**CITY OF SEATTLE  
ANALYSIS AND DECISION OF THE DIRECTOR  
OF THE DEPARTMENT OF PLANNING AND DEVELOPMENT  
AND RECOMMENDATION TO THE SUPERINTENDENT OF SEATTLE CITY LIGHT**

**Application Number:** 2201672  
**Applicant Name:** Gary Abrahams for T-Mobile Wireless  
**Address of Proposal:** 3246 32<sup>nd</sup> Ave W

**SUMMARY OF PROPOSED ACTION**

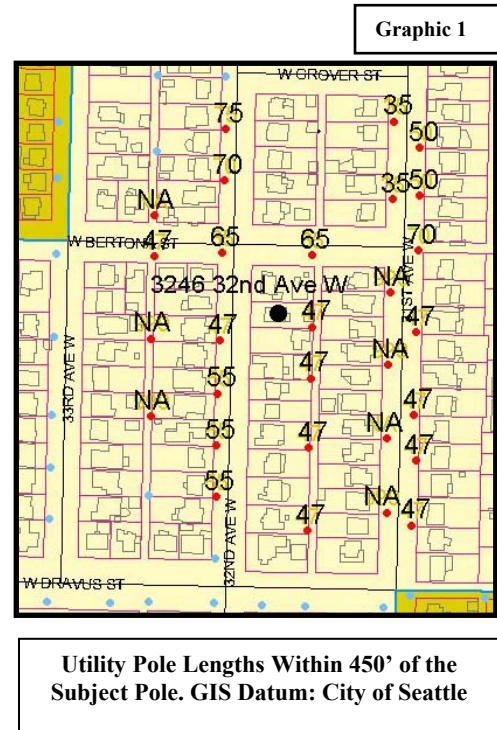
antennas will have detrimental effects to the visual character of the surrounding residential neighborhoods, for the following reasons:

1. The proposed laminated wood utility pole would be 19'-1" taller, not including the lighting rod) than the existing utility pole.
2. The proposed laminated wood utility pole design has both a shape and overall bulk that is rectangular, and is proportionally bigger than of a typical round wood utility pole. The overall dimension would be approximately 2'-1 1/2" x 1'-4 1/4", yielding a area of approximately 394 square inches where the existing pole has a area of approximately 176 square inches.

3. The proposed antennas and the antenna shroud are atypical of other equipment, including transformers, located in residentially zoned public rights-of-way. Specifically, the height of the shroud and antennas would make them highly visible. This is largely due to the fact that the proposed antenna would be located above the existing utility lines and would be 19'-1" taller than the existing utility pole.

4. The conduit cables are proposed to be exposed for approximately four (4) feet as they leave the top of the cable cover until they reach the bottom of the antenna housing, adding to the awkwardness of the pole when compared with the design of other utility poles in the area.

5. There are existing poles in the area that provide a context. The existing pole directly south, approximately 100' of the subject pole is approximately 40.3'<sup>\*\*</sup> in height and the pole directly north approximately 136' of the subject pole is 56.5'<sup>\*\*</sup> in height. The proposed pole at 61'-1", while close in height to a small number of poles in the area, will be out of character with the neighborhood. Table 1 below shows the approximate heights of the utility poles within 450' of the subject pole. While a limited number of poles in the area are of comparable height, the majority of the poles are 13.5+' less in height than the proposed height of the pole.
